# RotorSport UK Ltd Service Bulletin (Permit)

<b>Title: Pneumatic clutch III Pressure Plate inspection</b>		
<b>SB-128 Iss1</b>	<b>Related documents</b> Modification: MC- none CCAR No.: None	<b>Compliance Category:</b>
<b>Applicability</b>		<b>OPTIONAL or RECOMMENDED or MANDATORY</b>
<b>Aircraft type &amp; model:</b> MTOS2017 Cavalon	<b>Aircraft serial Nos. affected:</b> RSUK/MT02/004,06,07 and 08 RSUK/CVLN/027	
The maintenance manual to be referenced is this stated or subsequent issue.		MTOS2017 RSUK0395 Iss1 Calidus RSUK0061 Iss7 Cavalon RSUK0288 Iss5
This form is the response from RotorSport UK Ltd either against a problem found in the product in service requiring a containment or rectification action, or as service information for aircraft modification incorporation. For help, contact RotorSport on 44(0)1588 505060, or email <a href="mailto:compliance@rotorsport.org">compliance@rotorsport.org</a> .  The technical content of this document is approved under the authority of the UK CAA Design Organisation Approval Ref: <b>DAI/9917/06</b>

<b>Title: Pneumatic Clutch III (2017) – Pressure Disc Inspection</b>		
<b>AG-SB-2018-05-B-EN</b>		<b>Compliance Category:</b>
<b>Applicability<

Fig. 1 - Pressure Plate Assembly (31713)

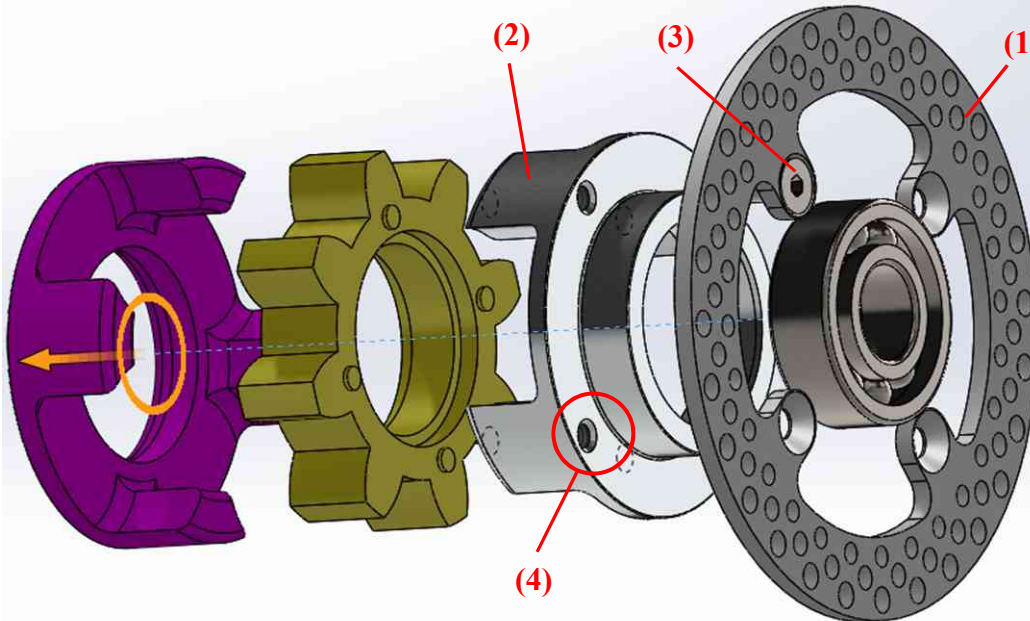
It has been found that the threaded holes in the first batch of pneumatic clutch III (2017) Pressure Plate front (2) are not sufficiently countersunk to accept the countersunk screws securing the Pressure Disc PKII (1). The effect is that the screws are unable to properly clamp the disc and plate together, possibly leading to looseness, rattle noise, and wear of this connection.

1. Remove any cowlings required to gain access to the clutch assembly.
2. Remove the pneumatic clutch from the engine in accordance with AMM job card 63-11-10 4-1.
3. Remove the center screw retaining the pressure plate assembly (31713) to the clutch in accordance with AMM job card 63-11-10 8-1 part 4.
4. Remove the pressure plate assembly (31713) from the clutch and remove the 4 countersunk screws (3) securing the pressure disc (1) to the pressure plate front (2).
5. Inspect for signs of rotational movement of the pressure disc (1) on the pressure plate front (2), and/or elongated holes in the disc (1). If damaged, replace (article 23604).
6. Inspect the complete clutch assembly for any further damage and replace any affected parts (eg. 31713 Pressure Plate Mounted).
7. Inspect the pressure plate front (2) and ensure that the threaded holes (4) are countersunk to a

- depth of 1mm with a 45° countersink. If not, re-work with a suitable countersink tool.
8. Re-assemble the clutch in reverse order of disassembly.
  9. Assemble the clutch to the engine in accordance with AMM job card 63-11-10 4-1.
  10. Re-fit any cowlings previously removed.
  11. Ground run the aircraft in a suitably secured area, including a pre-rotation clutch functional check.
  12. Note the SB action within the aircraft documentation.
